X3T9.2/93-112r1
 X3T9.2/92-139r2
 SFF-8009

Date: July 28, 1993

Subject: UNITIZED CONNECTOR PIN ASSIGNMENTS

Auxiliary Pinouts

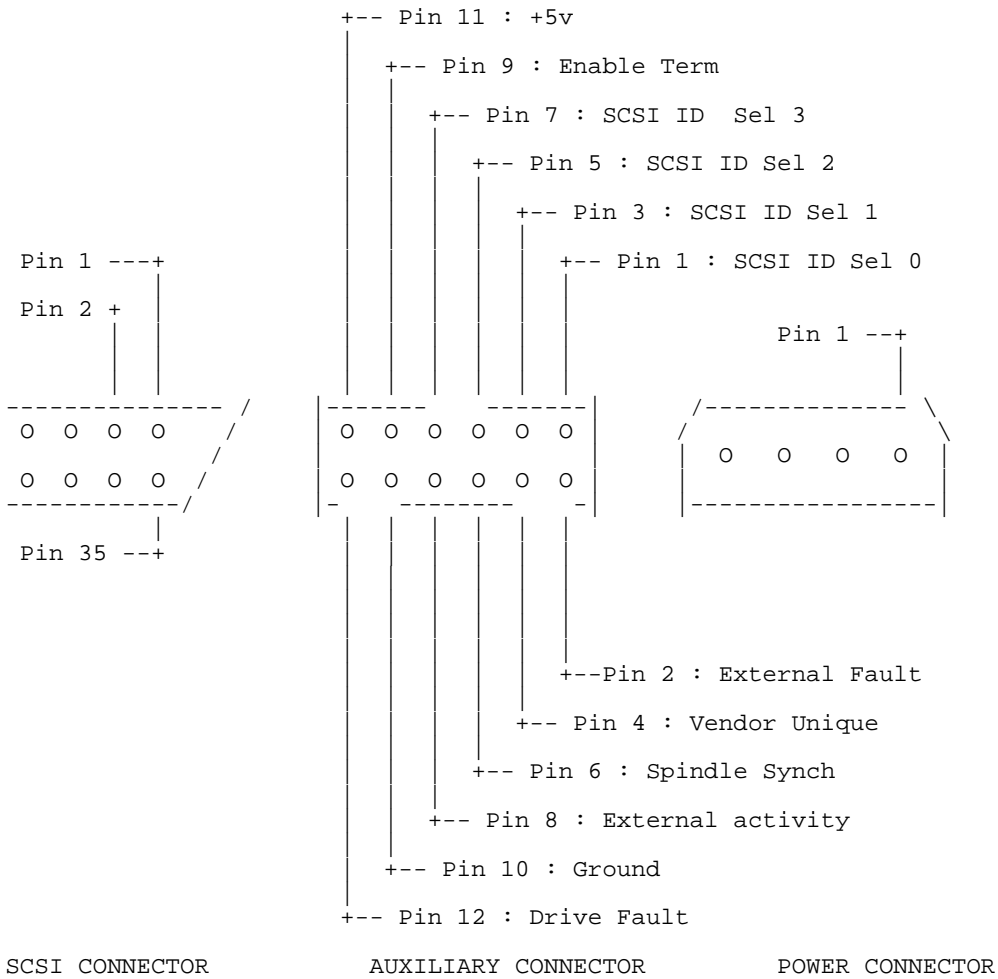
GEM COMMENT: Because of the jumpering, the Vendor Unique pin can not be vendor unique during the Initialization time. During that time it must conform to the stated requirements (in the revised document) in order to make the ID selection work. This may impose restrictions on the VU implementation even after Initialization. In addition I do not think it will work to allow VU to be either an input or an output. I think it has to stay as documented an output from the device. Otherwise this may blow some mixtures. I suppose an alternative would be to require that the host and devices which provide an output must use a "wired Or" capable circuit. Should we have asked if anyone was using VU? Should we have reclaimed it as reserved? Sorry did not think of that before.

LJL COMMENT: This signal seems to imply that switchable terminators are required. In our experience a number of customers do not want switchable terminators. Should this be an optional feature?

LJL COMMENT: What is the tolerance on the +5 V dc?
